**HISTORIC PRESERVATION REVIEW BOARD
STAFF REPORT AND RECOMMENDATION**

| Property Address: | 422 Butternut Street, NW | X Agenda |
| Landmark/District: | Takoma Park Historic District | Consent Calendar |
| H.P.A. Number: | 19-597 | X Alteration |

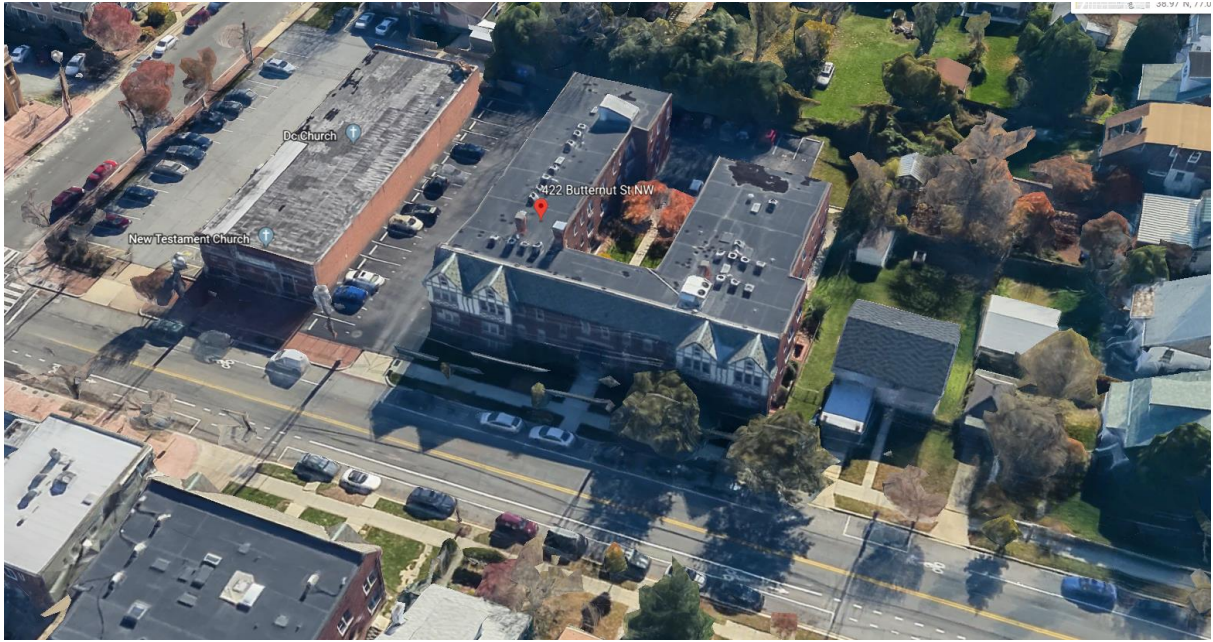
The existing slate roof is an original character-defining feature of the building. While the Board has occasionally approved alternative materials where they were not particularly distinctive or important in defining the character of a property, it has typically required in-kind replacement of distinctive materials when they are proposed for replacement.

While replacement in true slate would be the best preservation solution (and provide the longest lifespan), the synthetic slate would replicate the size, scale, texture, reflectivity and range of color of the existing slate roof. While the applicant's preferred asphalt shingle would replicate the general size and scale of the slates, it would not replicate these other visual characteristics.

The HPO recommends that the Board find the concept for replacing the original slate with asphalt shingle to be inconsistent with the preservation act, as it would not retain or replicate an important character-defining feature of the building. HPO recommends that the Board find replacement in synthetic slate to be compatible contingent on the existing color range be replicated.
